**Proposed Wellsite
Sutton's Lane, Great Altcar
Supplementary Transport Statement**

November 2019

PLANNING APPLICATION LCC/2019/0037 – PROPOSED HYDROCARBON EXPLORATION SITE AT SUTTONS LANE, GREAT ALTCAR, FORMBY

Key:-

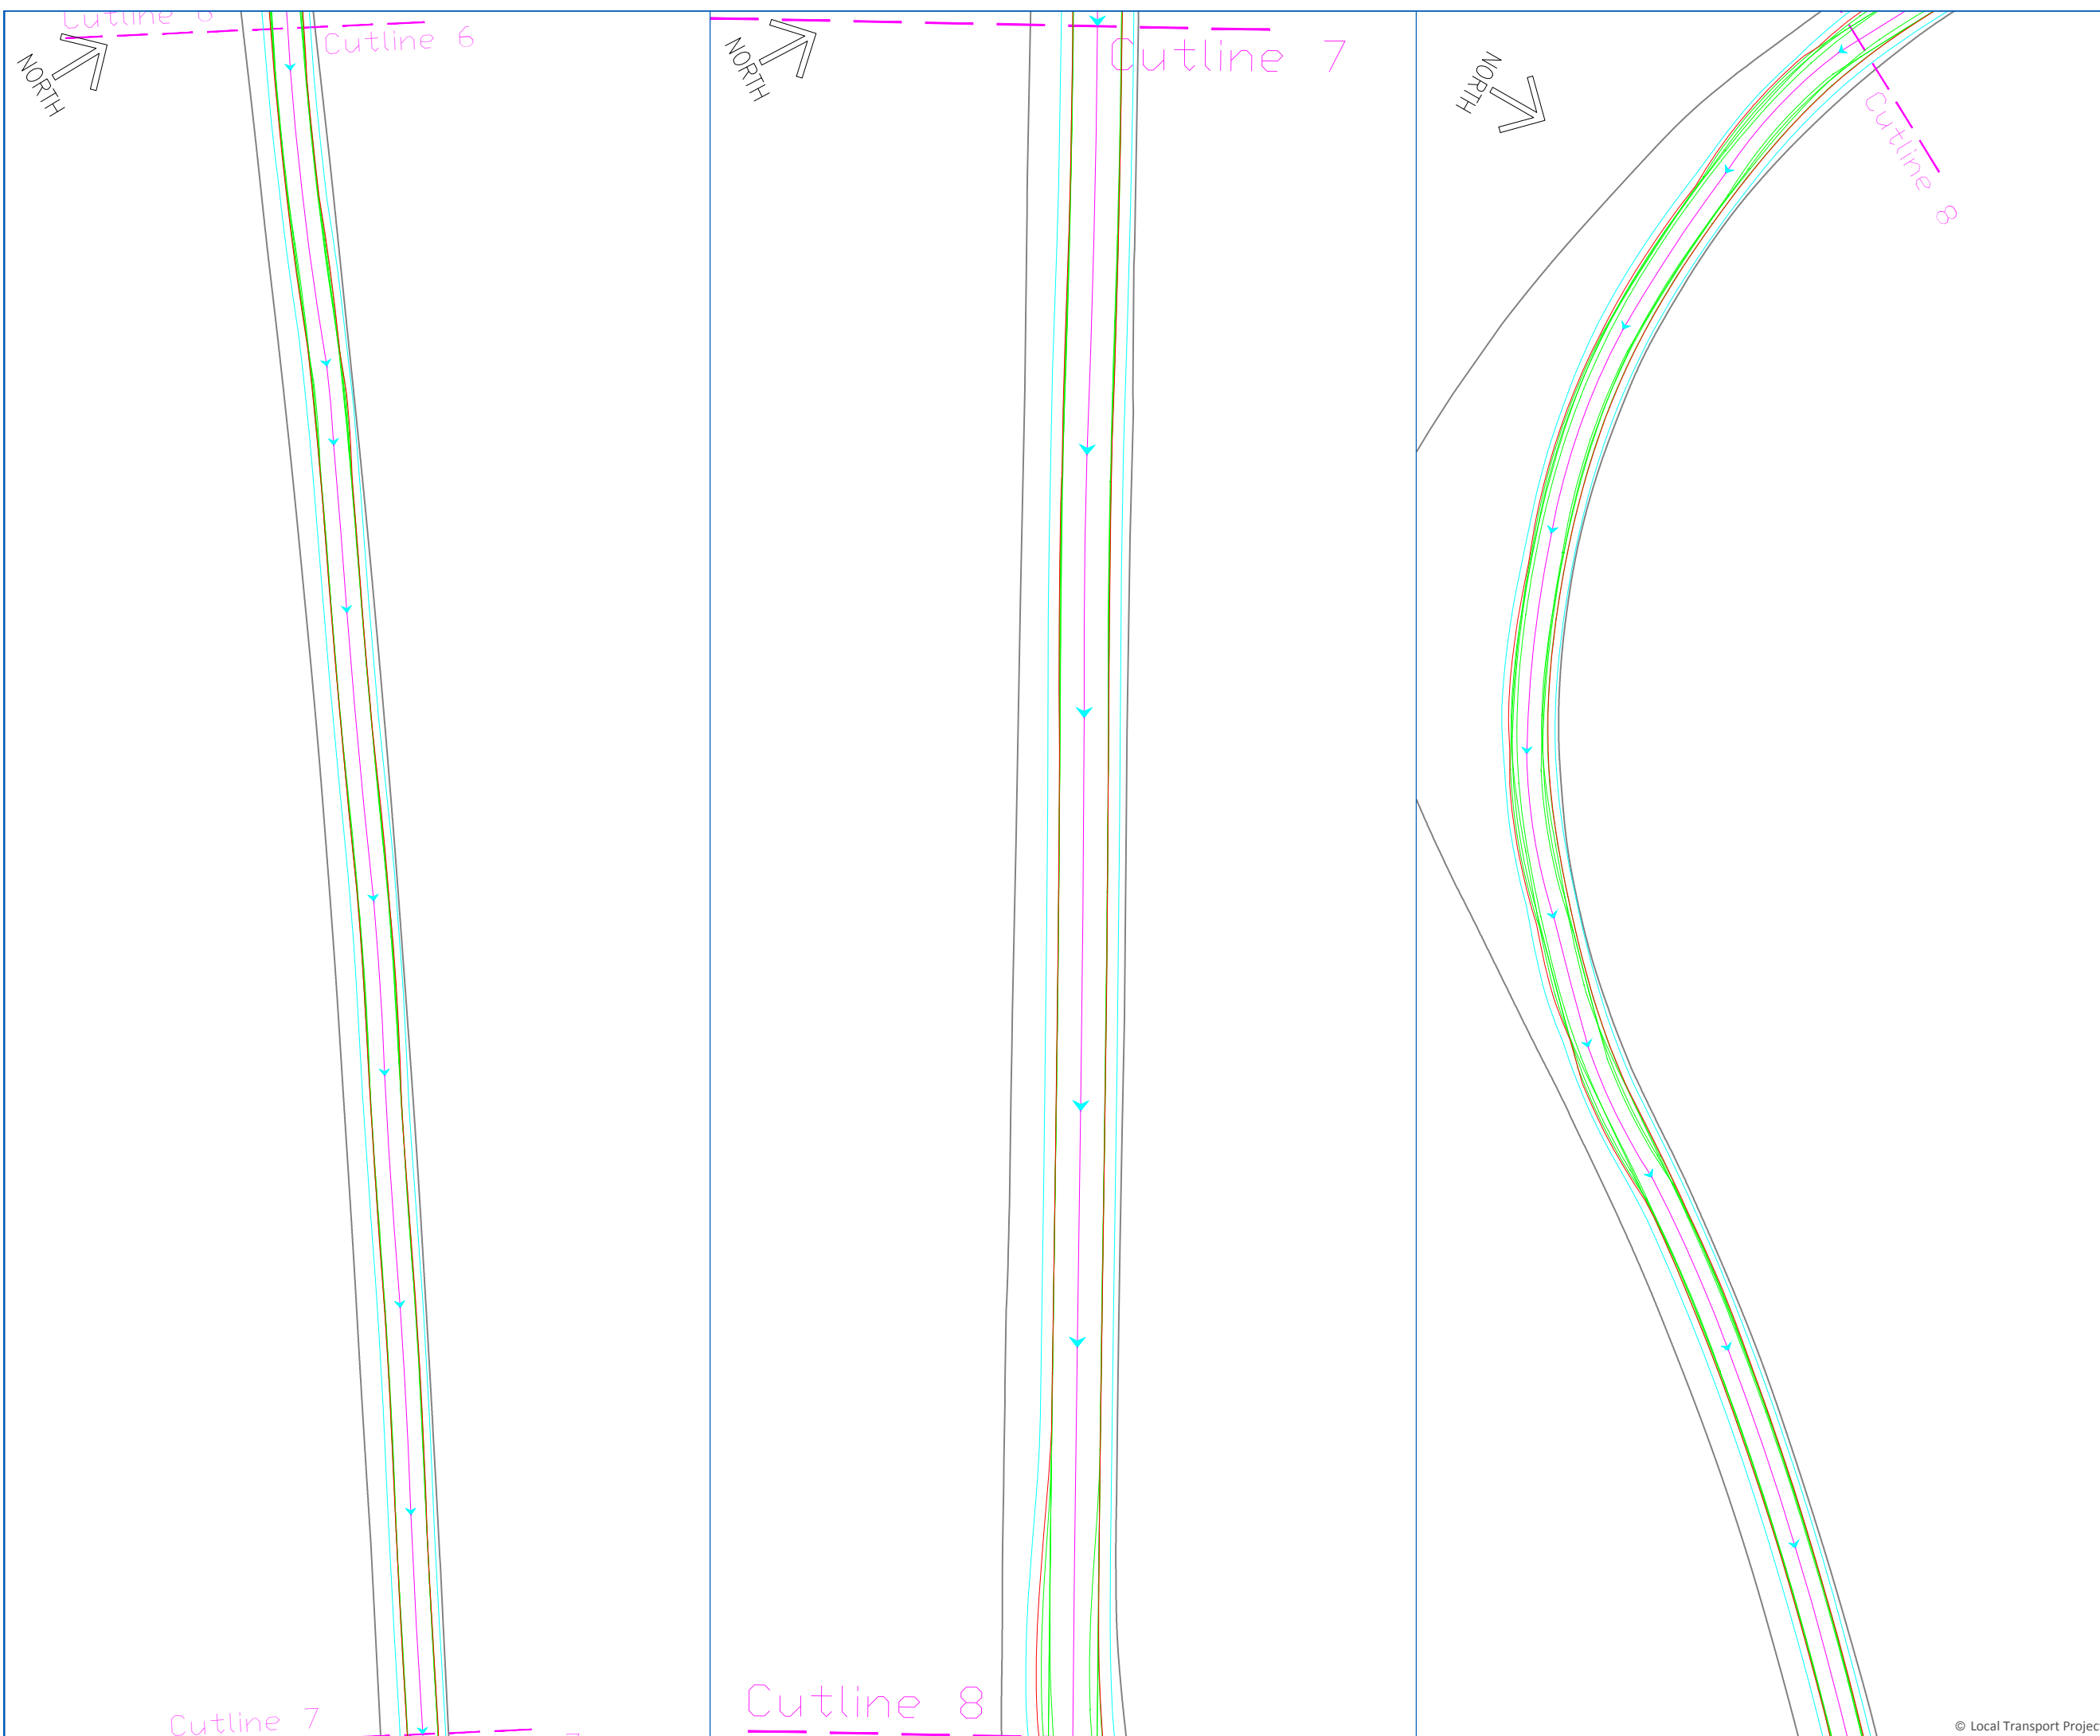
- 4.1.1 **Regulation 25 Request (Appendix 1) – SC Highways:** “Sefton also make comment about abnormal loads in particular the Active Mud Tank Transport. I note that you have included swept path diagrams for this vehicle and Sefton note that this vehicle would have to cross into the opposite carriageway to pass the Altcar Road/Stephenson Way roundabout and would have to cross a bridge on the Sefton/Lancashire boundary. In assessing the highway impacts of this abnormal load, it would be useful to know how often this vehicle would access the site and its total weight. You should also take into account Sefton's observations regarding on street parking but my own observations are that there are 'no parking' restrictions around the Altcar Road/Stephenson Way roundabout which should prevent parking in that particular location.”

- Sefton also make comment about abnormal loads in particular the Active Mud Tank Transport. I note that you have included swept path diagrams for this vehicle and Sefton note that this vehicle would have to cross into the opposite carriageway to pass the Altcar Road/Stephenson Way roundabout and would have to cross a bridge on the

- 4.1.5 The largest vehicle has been identified as the transport for the Active Mud Tank, which will generate two (2) movements, once upon mobilisation of the drilling rig, and then again upon demobilisation of the rig. There are expected to be some movements of smaller abnormal loads, although the number of movements is small, with 20 other parts of the rig that need to be transported to the site upon mobilisation of the rig (and the transported away as part of demobilisation). It is worth noting that the vehicles transporting the abnormal loads will require less/no traffic management before/after the material/equipment is loaded onto the vehicle.

- 4.1.6 It is acknowledged that, even with traffic management, the access routes still need to be wide enough and suitable to accommodate these AILVs. As a principal road, it is expected that the movement of AILVs can be accommodated on the dual carriageway A565 without mitigation (but with suitable traffic management). However, in order to ensure that the access route between the A565 and the site can also accommodate AILV movements, swept path analysis has been undertaken for the largest AILV expected to visit the site. As part of the TS, the proposed delivery route was assessed in order to identify key locations for testing, with only Sutton's Lane and the Altcar Road (B5195)/Stephenson Way roundabout requiring assessment. However, this testing has been extended as part of this STS in order to cover the full route between the A565 and the site, as shown in Appendix 2.

- 4.1.7 This swept path analysis shows that, even the largest AILV, there is no expected overrunning or overhanging beyond the carriageway along the full route, including the section within the SC area. It is acknowledged that, as is the case with a significant proportion of AILV movements, the vehicles would be required to partially cross over the centreline on single carriageway roads, hence the requirement for specific traffic management measures.
